AGENDA
City of Salmon Arm
Development and Planning Services
Committee

Tuesday, September 20, 2022
8:00 a.m.

SUBJECT: Development Variance Permit Application No. VP-558 (Servicing)
 Legal: Lot 1, Section 12, Township 20, Range 10, W6M, KDYD, Plan 2915
 Civic Address: 1660 20 Street SE
 Owner/Applicant: Arlene Brown

TO: Kevin Pearson, Director of Development Services
 DATE: July 27, 2022
 PREPARED BY: Mustafa Zakreet, Engineering Assistant
 OWNER: G& V. Brown.
 APPLICANT: G& V. Brown.
 SUBJECT: **VARIANCE PERMIT APPLICATION FILE NO. VP- 558**
 LEGAL: Lot 1, Section 12, Township 20, Range 10, W6M, KDYD, Plan 2915
 CIVIC: **1660 – 20 Street SE**

Figure 1

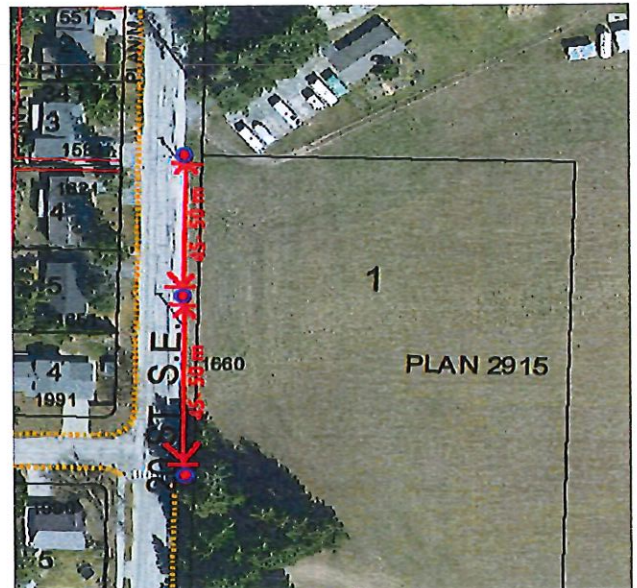
1. Waive the requirement to install streetlights on 20 Street SE along the entire frontage of the subject property.

Currently, there is only one street light on a BC hydro pole at the marked location (+) shown in Figure 2. The City Capital Works Supervisor has provided the design and estimate to include three davit street lights as marked on Figure 1. Since the City owned street lights cost the City a fraction of the cost of hydro lights annually, the City has been working to reduce the amount of hydro lease lights and ensuring that developers install City owned lights. The provided estimate of \$24,800 includes the replacement of the already existed BC hydro street light with a City davit street light and adding two more street lights to cover the frontage of this property.

Recommendation:

The Engineering Department recommends that the requested variance to waive the requirement to install street lights along the frontage of the subject property be denied.

Figure 2

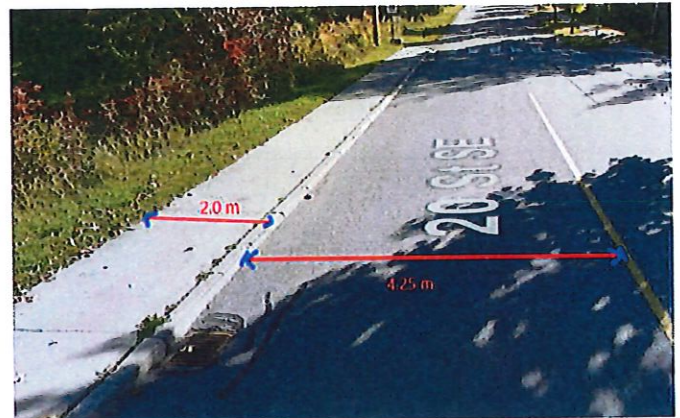
2. Waive the requirement to construct a bike lane on 20 Street SE along the entire frontage of the subject property.

20 Street SE is designated as collector road and is an important link from residential areas to an elementary school as well as to the trail network at Shuswap Memorial Cemetery. The east lane of 20 Street SE requires widening by approximately 0.75m to accommodate a bike lane. The sidewalk, curb and gutter which would require relocating not to the City standard (location and style).

The cost estimate provided by the City capital work supervisor for the described work is \$72,000 (see appendix B). The City has been moving towards changing the Collector Roadway standard from a bike lane and sidewalk to a separated Multi-use pathway. As such we would recommend a Cash-in-lieu payment for the bike lane to be put towards replacing the sidewalk with a multi-use path in the future.

Recommendation:

The Engineering Department recommends that the requested variance to waive the requirement to install a bike lane along the frontage of the subject property be denied.
